# HISTORIC AND DESIGN REVIEW COMMISSION

June 28, 2024

**HDRC CASE NO:** 2024-214  
**ADDRESS:** 1002 KAMPMANN BLVD  
**LEGAL DESCRIPTION:** NCB 7011 BLK LOT 9 & W 48 FT OF 8  
**ZONING:** RM-4, H  
**CITY COUNCIL DIST.:** 7  
**DISTRICT:** Monticello Park Historic District  
**APPLICANT:** Adan Ochoa/AO Design, LLC  
**OWNER:** RYAN NATASHA  
**TYPE OF WORK:** Balcony and fenestration modifications  
**APPLICATION RECEIVED:** June 07, 2024  
**60-DAY REVIEW:** August 6, 2024  
**CASE MANAGER:** Claudia Espinosa

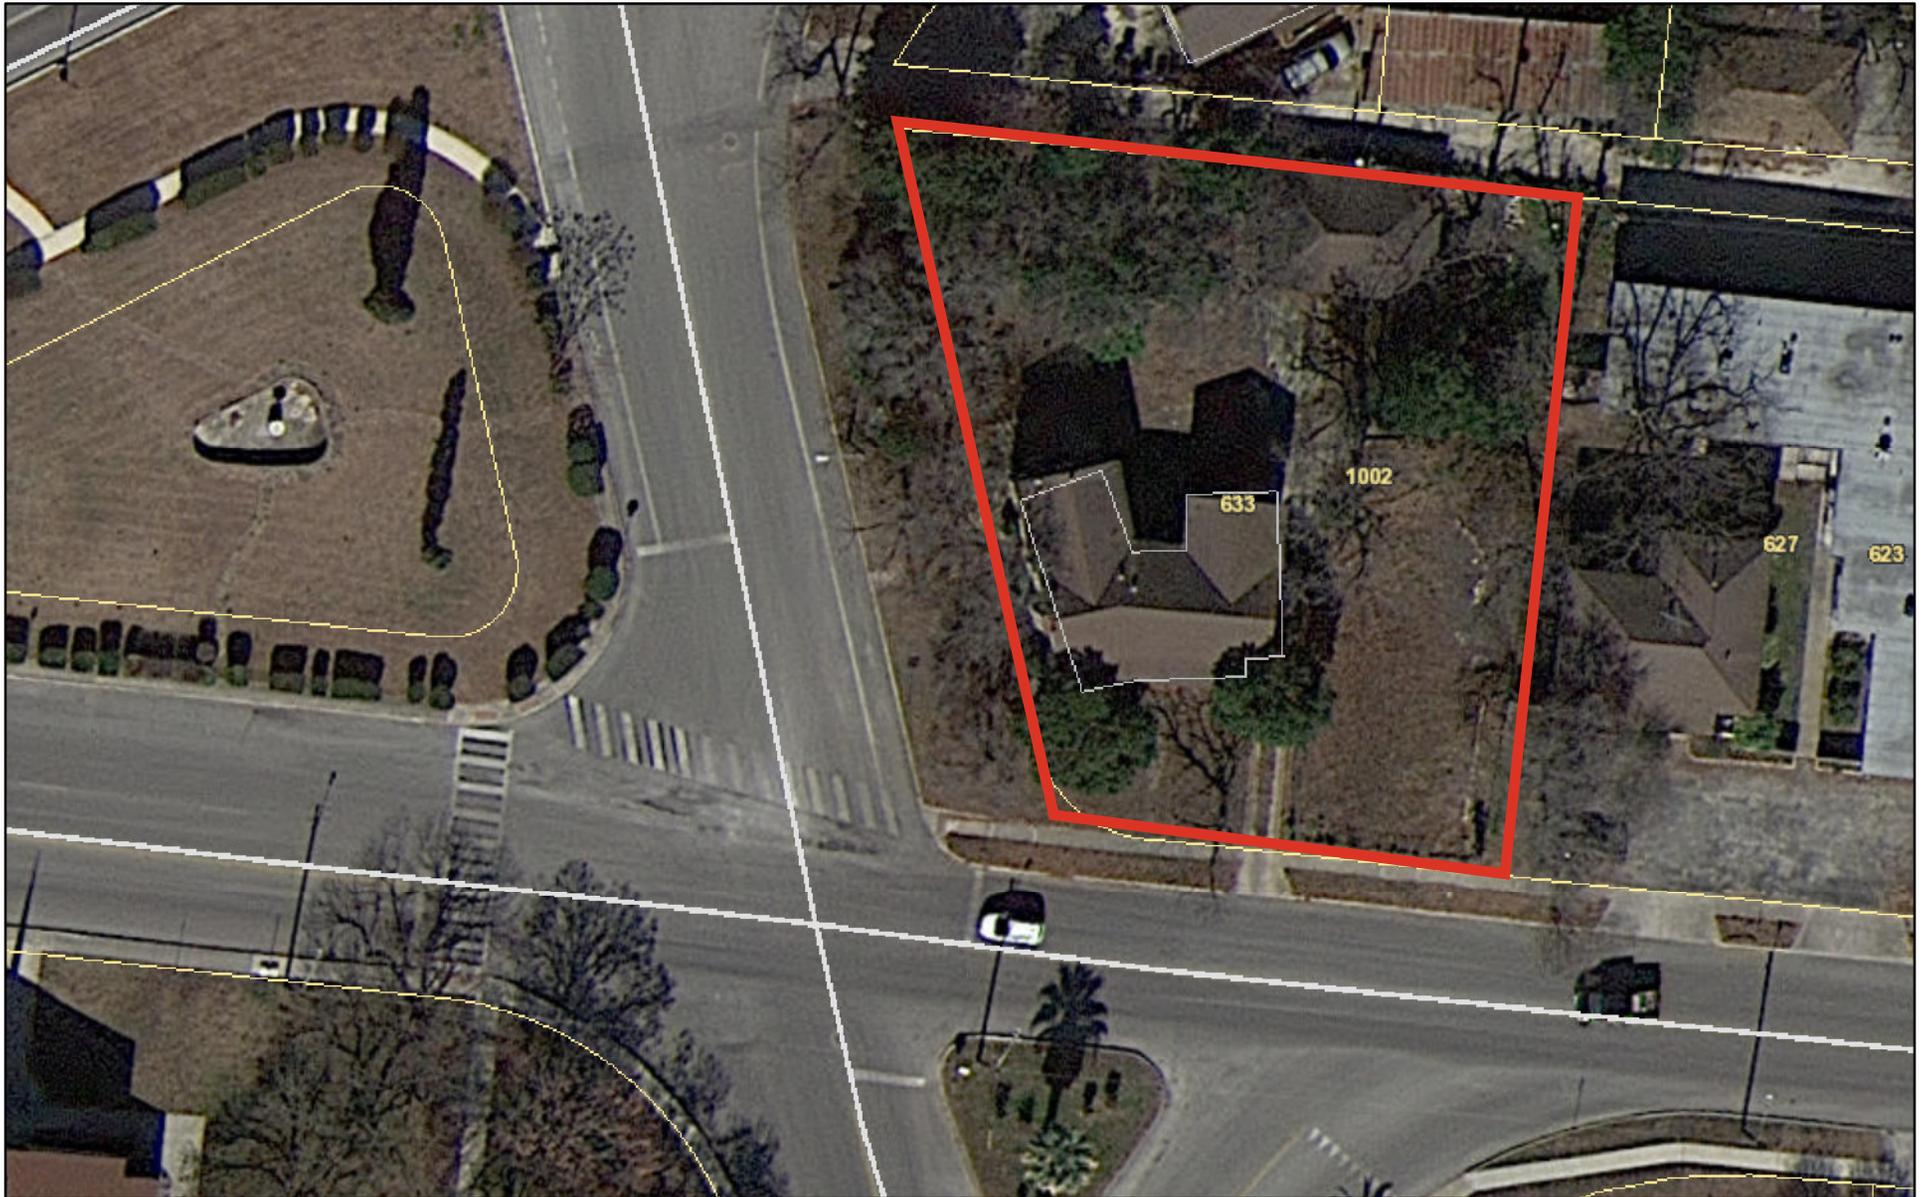
Item 1, staff does not recommend approval of the modifications to the second-story cantilever balcony, based on finding b.

**1** SITE PLAN  
Scale: NOT TO SCALE

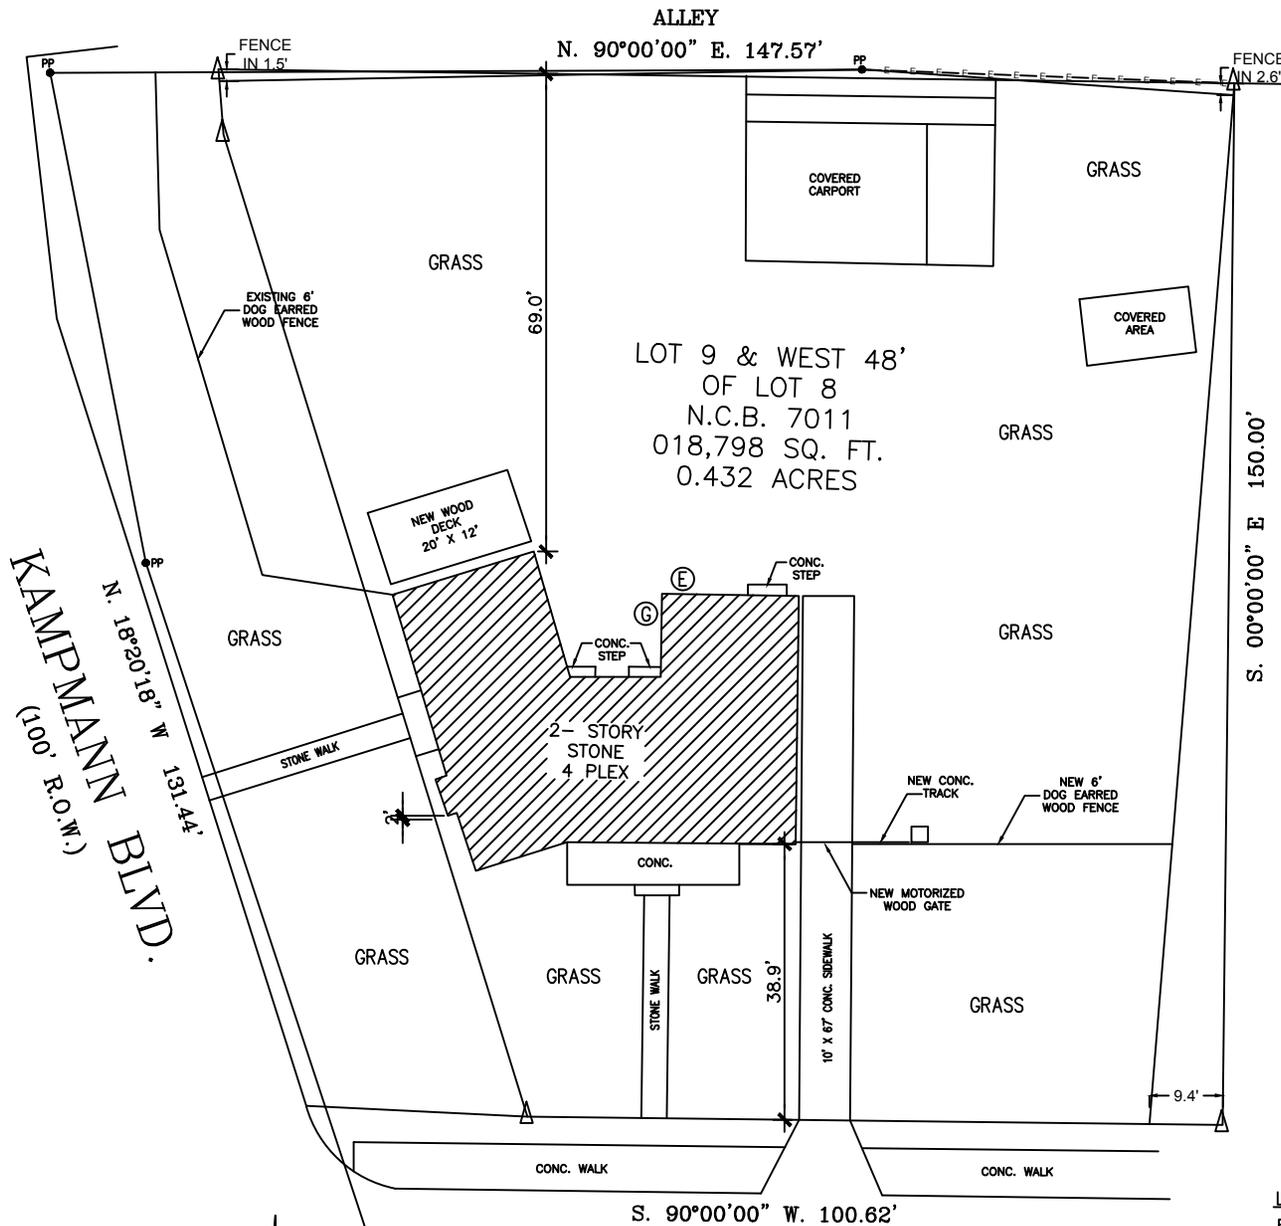
- b. DONALDSON PORCH MODIFICATIONS – The applicant has proposed to modify the existing cantilevered second-story balcony on the south facade by installing shingle awnings, that would extend from the second-floor balcony, over the concrete slab of the front porch with 6x6 wood columns, that feature both capital and base trim and chamfered corners. The modification will create a prominent front porch on the south facade. The Guidelines for Exterior Maintenance and Alterations 7.B.iv. notes that elements and details that create a false historic appearance should not be added. Second-story cantilevered balconies are character-defining features of Monterey-style structures; therefore, staff finds that the request is inconsistent with the Guidelines.

- c. FENESTRATION MODIFICATION (GANGED WINDOWS TO FRENCH DOORS)– The applicant has proposed to convert the existing ganged window opening on the rear (north) elevation (annotated as #4 on the north elevation photo in the exhibits) into a French Door opening. Per the Guidelines for Exterior Maintenance and Alterations 6.B.ii, ensure that new entrances, when necessary to comply with other regulations, are compatible in size, scale, shape, proportion, material, and massing with historic entrances. Staff finds the proposed conversion from a window opening to a door opening to be consistent with the Guidelines for Exterior Maintenance and Alterations.

- d. FENESTRATION MODIFICATION (WINDOW TO DOOR)– The applicant has proposed to convert an existing window opening on the rear (north) elevation (annotated as #1 on the north elevation photo in the exhibits) into a single door opening. Per the Guidelines for Exterior Maintenance and Alterations 6.B.ii, ensure that new entrances, when necessary to comply with other regulations, are compatible in size, scale, shape, proportion, material, and massing with historic entrances. Staff finds the proposed conversion from a window opening to a door opening to be consistent with the Guidelines for Exterior Maintenance and Alterations.

Item 2, staff recommends approval of the modification of the pair of ganged windows to accommodate a French door, based on finding c with the following stipulation:

- i. That any stone removed from the structure be retained and stored on the property for future use.
- ii. That the removed windows be retained and stored on the property for future use.

Item 3, staff recommends approval of the modification of one window opening on the rear of the structure to be modified to a single door opening, based on finding d with the following stipulation:

- i. That any stone removed from the structure be retained and stored for future use.
- ii. That the removed windows be retained and stored on the property for future use.
